Corporate Environmental Programs
General Electric Company
100 Woodlawn Avenue, Pittsfield, MA 01201

August 20, 2002

**Re: GE-Pittsfield/Housatonic River Site
Newell Street Area I (GEC440)
Revised Proposal for Supplemental Pre-Design Investigations**

**GENERAL ELECTRIC COMPANY
PITTSFIELD, MASSACHUSETTS
NEWELL STREET AREA I
REVISED SUPPLEMENTAL SAMPLING PROPOSAL
NON-PCB SOIL SAMPLE LOCATIONS
WITHIN 0- TO 1-FOOT
DEPTH INCREMENT**

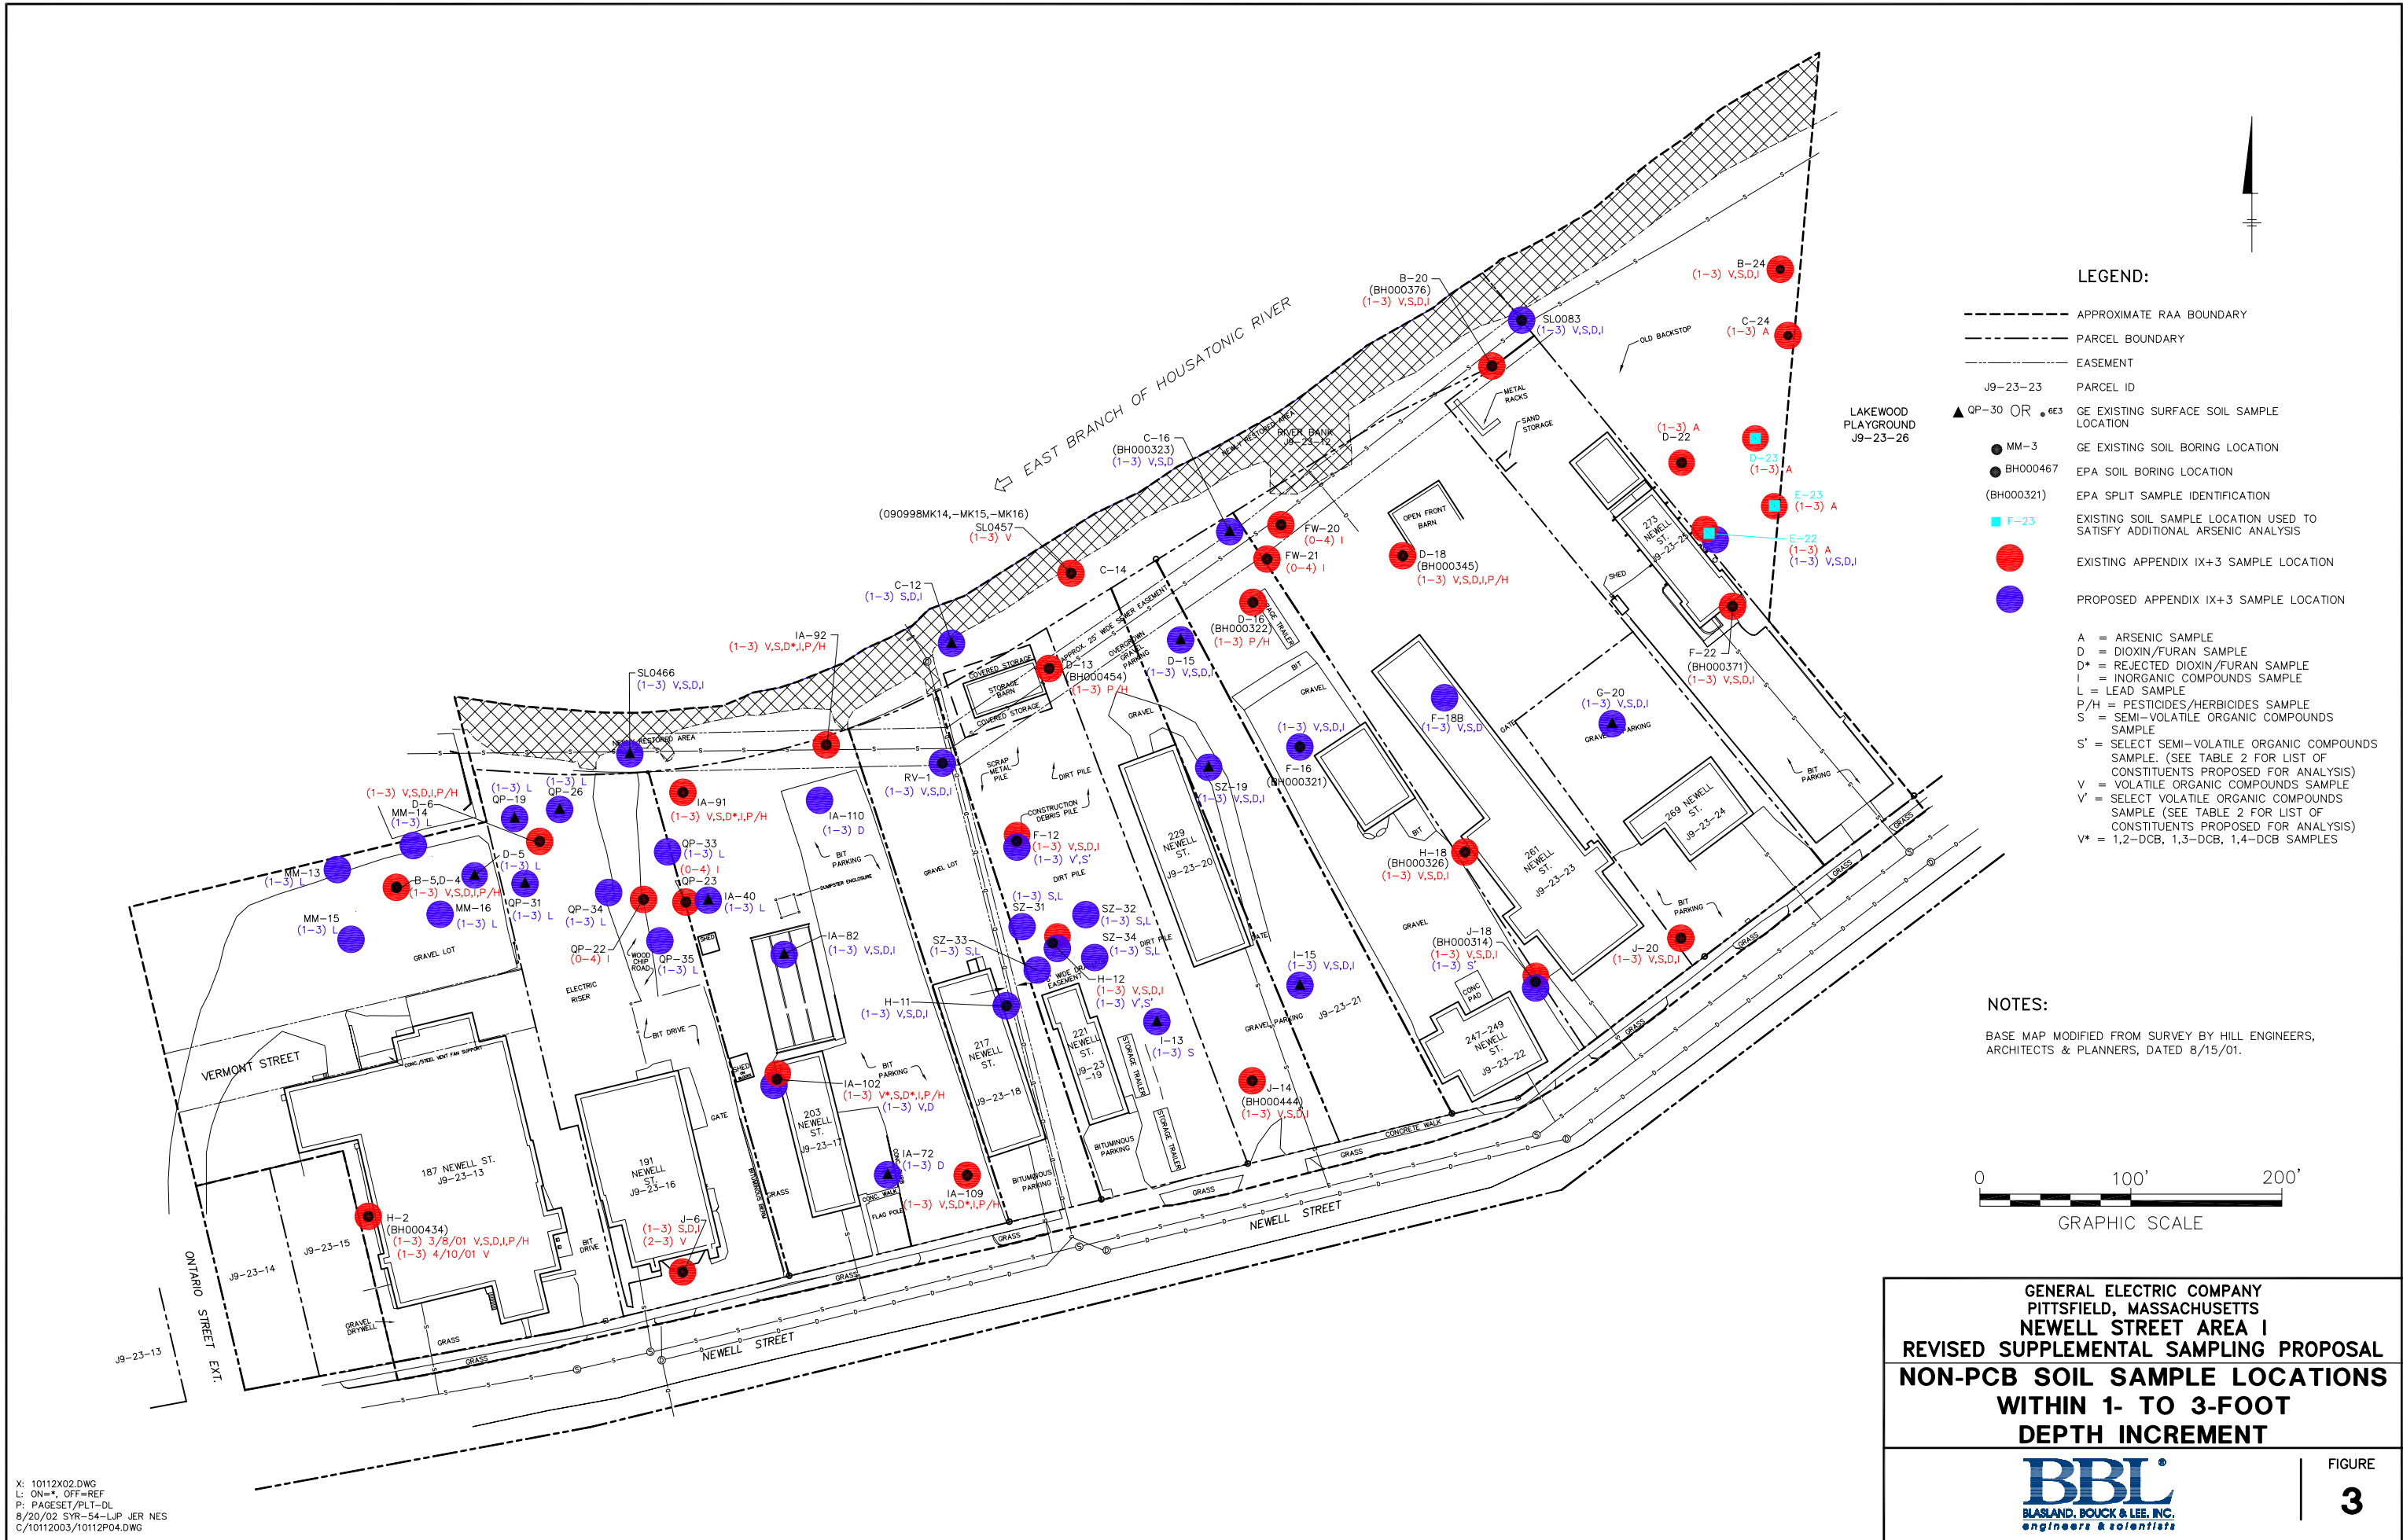
0- to 1-Foot Depth Increment: Based on both the Supplemental Proposal and EPA’s August 5, 2002 letter (Comment 2a), there are five prior sample locations that showed elevated concentrations of lead in the uppermost depth increment and for which lead delineation is thus needed in the 0- to 1-foot depth. These consist of the samples from locations J9-23-13-D5 (0-1’), J9-23-16-QP-23 (0-4’), J9-23-16-QP-25 (0-0.5’), J9-23-16-QP-26 (0-0.5’), and J9-23-17-IA-93 (0-1’). These sample locations are all situated within the same general area, as shown on Figure 2. Moreover, all these locations are well within the area for which GE has proposed a minimum of 1-foot soil removal to address PCBs, as shown on Figure 3-1 of the Conceptual Work Plan. In these circumstances, GE does not believe that it makes sense to attempt to delineate the extent of elevated lead concentrations in the top foot of soil around each of these locations individually (since the entire top foot of soil in this area will be removed anyway). Rather, GE proposes to conduct additional surface soil sampling for lead near the edges of the proposed PCB removal area in order to assess whether the extent of elevated lead concentrations extend beyond the proposed PCB soil removal limits. There are a number of existing surface soil samples near (or relatively near) the edges of the proposed PCB removal area that have previously been analyzed for lead and thus can be used for this purpose. These include the samples from MM-SS-1 (0-1’), SLO466 (0-0.5’), D9 (0-1’), IA-25 (0-0.5’), and IA-96 (0-1’), as shown on Figure 2. To supplement these existing data, GE proposes to collect additional 0- to 1-foot soil samples for lead analysis from the following locations near the edges of the proposed PCB removal area: MM-14, MM-15, MM-6(BBL), SLO102, QP-14, QP-35, IA-94, and IA-97. These locations (which have been revised from the lead delineation locations proposed for this depth interval in the Supplemental Proposal) are shown on Figure 2.

Supplemental Appendix IX+3 Soil Sampling: In accordance with Comment 1 of EPA's August 5, 2002 letter, GE has made the following changes regarding the proposed Appendix IX+3 samples at this property, as indicated on Figures 2 and 3:

- The proposed sample for the 0- to 1-foot depth increment at location SZ-36 will be moved to a location between the storage trailer and the building along the "I" grid line;
- A new sample will be collected at location SZ-32 from the 0- to 1-foot depth increment for analysis of SVOCs;
- The proposed sample for the 1- to 3-foot depth increment at location SZ-31 will be moved to a location along the property line between Parcels J9-23-18 and J9-23-19 and along the "G" grid line; and
- A new sample will be collected at location I13 from the 1- to 3-foot depth increment for analysis of SVOCs.

**GENERAL ELECTRIC COMPANY
PITTSFIELD, MASSACHUSETTS
NEWELL STREET AREA I
REVISED SUPPLEMENTAL SAMPLING PROPOSAL
NON-PCB SOIL SAMPLE LOCATIONS
WITHIN 1- TO 3-FOOT
DEPTH INCREMENT**

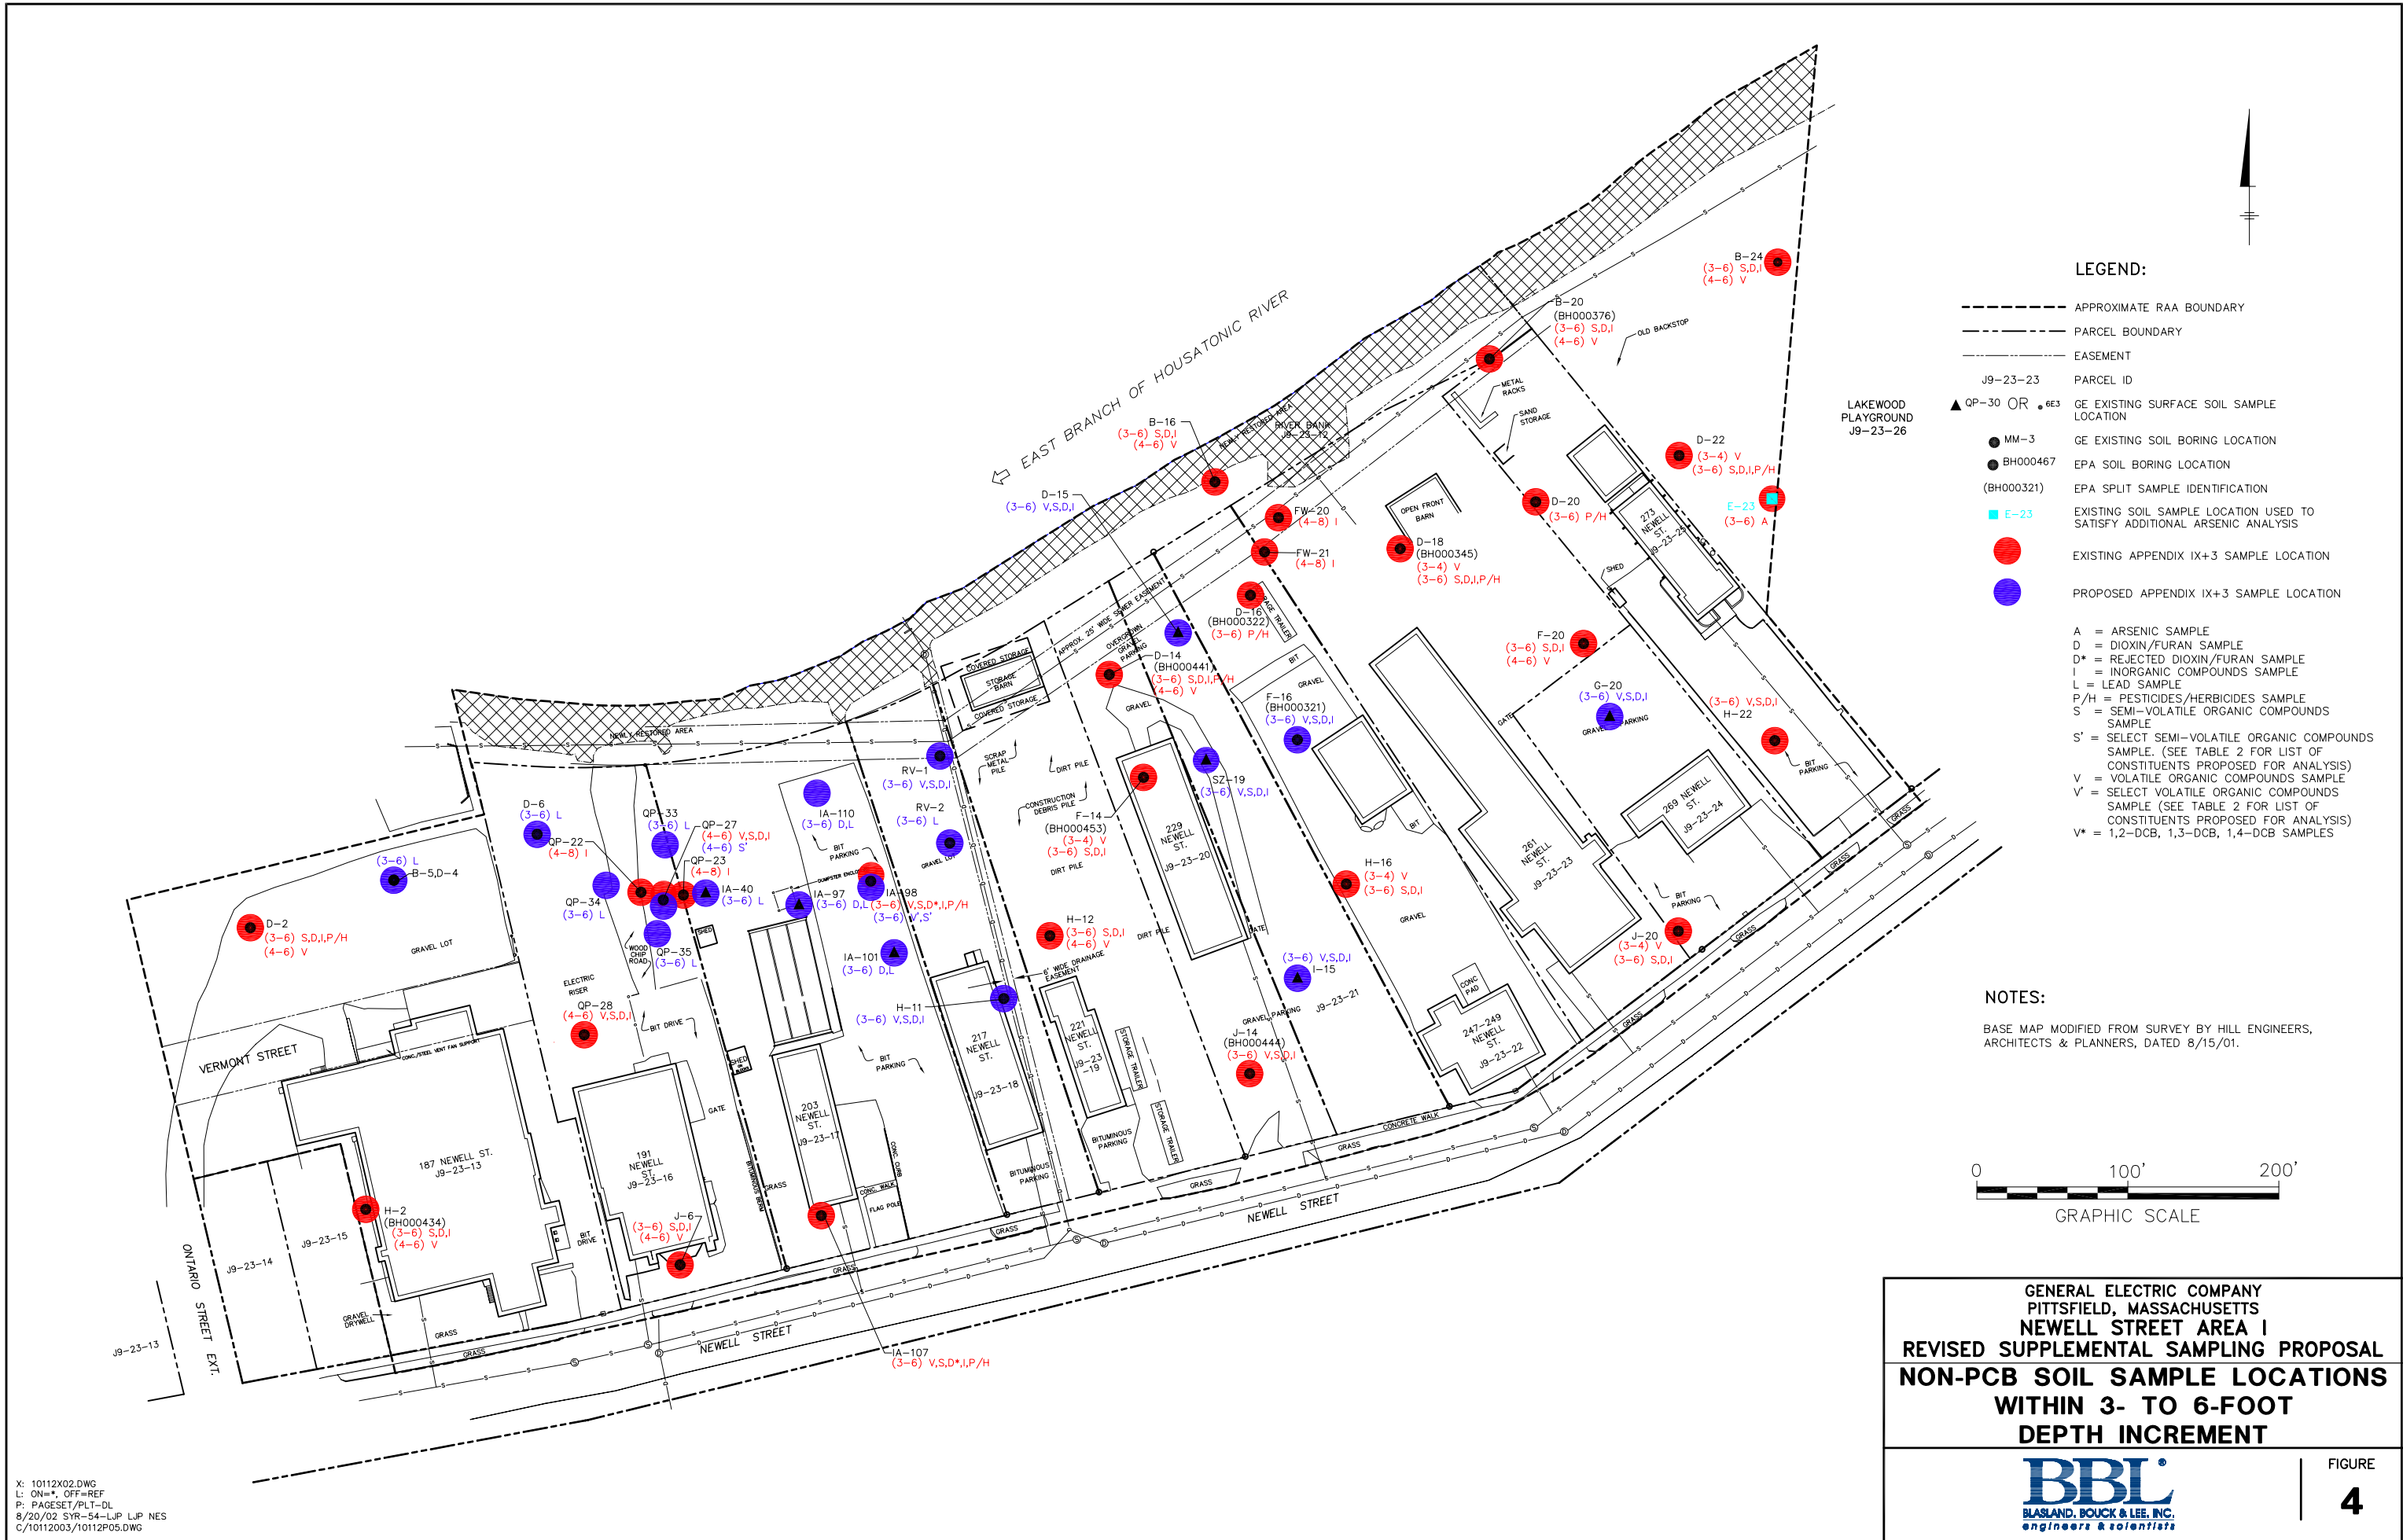
1- to 3-Foot Depth Increment: There are three prior samples from this area with elevated lead concentrations that require further horizontal delineation for lead in the 1- to 3-foot depth increment. These are samples from locations D4 (1-3’), D6 (1-3’), and QP-23 (0-4’), as shown on Figure 3. To delineate the extent of elevated lead concentrations for these locations in the 1- to 3-foot depth increment, GE proposes to collect soil samples for lead analysis from the 1- to 3-foot depth at the following locations, as shown on Figure 3: MM-13, MM-14, MM-15, MM-16, QP-19, QP-26, QP-31, QP-33, QP-34, QP-35, and IA-40.
